City of Seattle

**CITY OF SEATTLE
ANALYSIS, RECOMMENDATION AND DETERMINATION OF
THE DIRECTOR OF THE DEPARTMENT OF PLANNING AND DEVELOPMENT**

Application Number: 3012953
Applicant Name: Swedish Medical Center Cherry Hill
Address of Proposal: 500 17th Avenue

Figure 2. Proposed MIO Heights

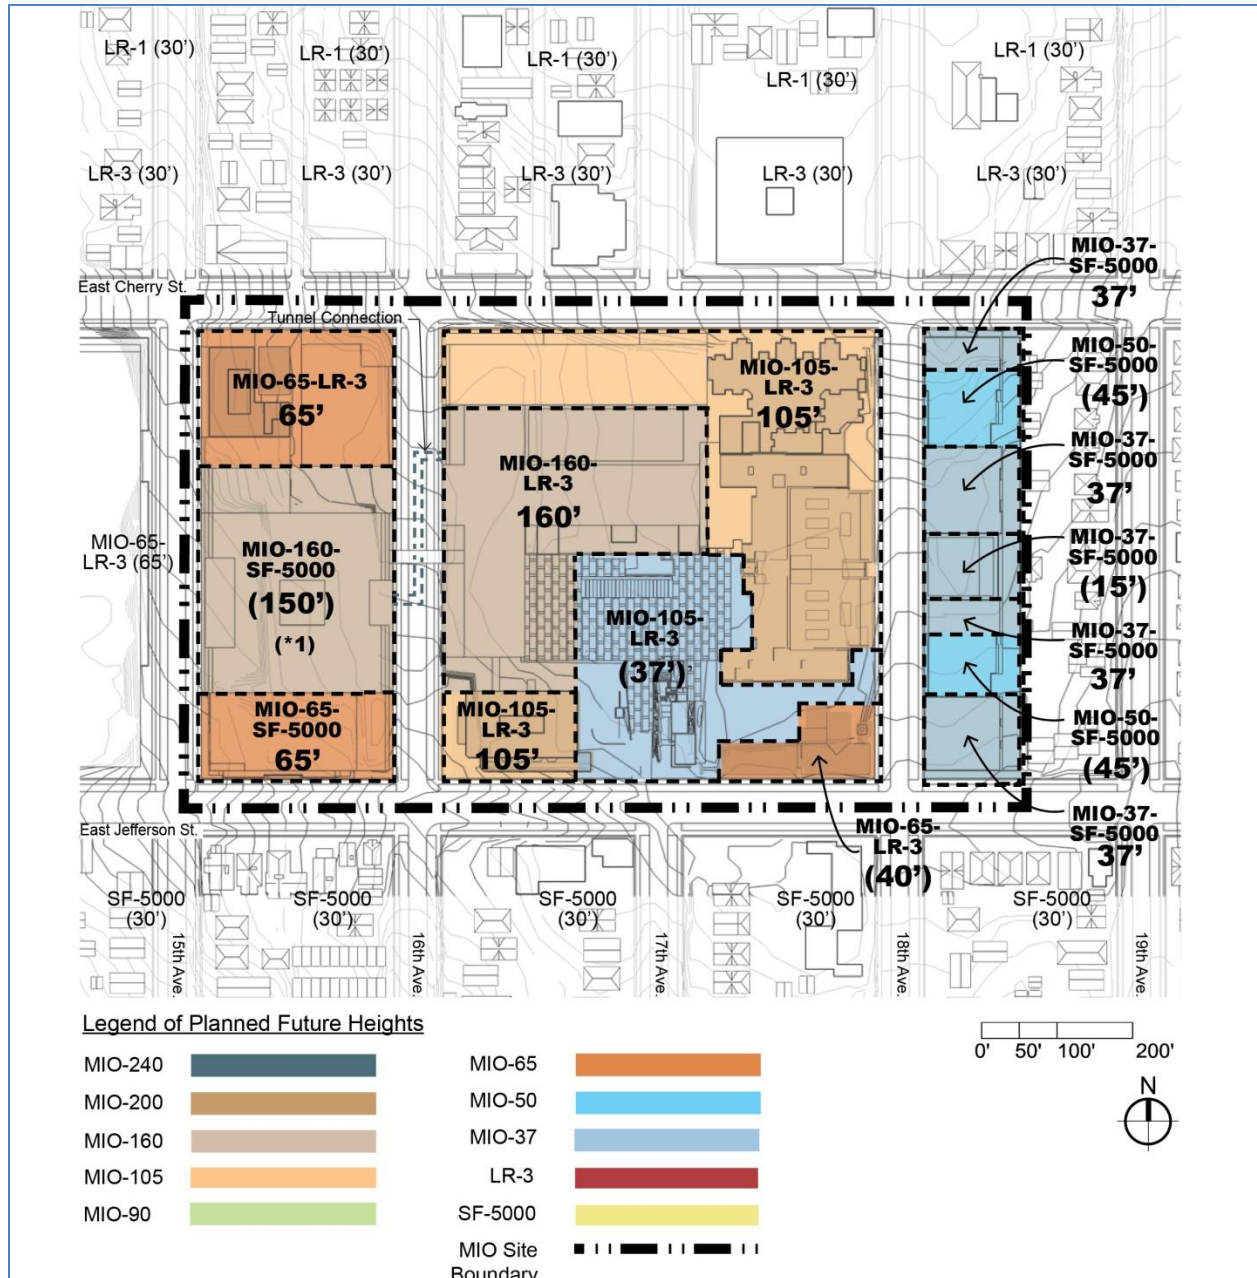
As described above, Figure 2 of this report identifies both the MIO height districts listed in SMC 23.69.004, and show in parenthesis lower heights that Swedish Cherry Hill has proposed to maintain for the duration of the Master Plan. Those lower heights are denoted as “conditioned heights.”

DPD concludes that the proposed MIO height districts of MIO-37, -65, 105, and 160 with lower heights conditioned as shown on Figure 2 of this report, and on Figure B-2 through B-10 of the Master Plan, and the proposed setbacks as shown on Figures 10-18 and described in Table B-2 of the Master Plan, as conditioned or revised below, fosters an appropriate transition both to the lower neighborhood zones (SF5000 and LR3) to the north, south and east, as well as to the MIO-65 zoning of the Seattle University campus that faces the Swedish Chery Hill campus across 15th Avenue.

Additional height is proposed for three areas of the campus (see Figure 2 of this report). On the West Campus, Swedish Cherry Hill is proposing MIO-160 conditioned down to 150 feet for the central portion of the block. On the Central Campus, Swedish is proposing MIO-160 for a central portion of that block that faces onto 16th Avenue. On the north and south portions of the east half-block Swedish is proposing to increase the MIO height from 37 feet to 50 feet, conditioned down to a 45 height.

The Director recommends **CONDITIONAL APPROVAL** of the proposed modifications to MIO height districts on the western and central blocks as shown on Figure 2 of this report, and include MIO-37, MIO-65, MIO-105, and MIO-160 subject to conditions outlined in Section VII. The Director recommends **DENIAL** of the MIO – 50 (conditioned down to 45) on the east half block as shown on Figure 2 of this report.
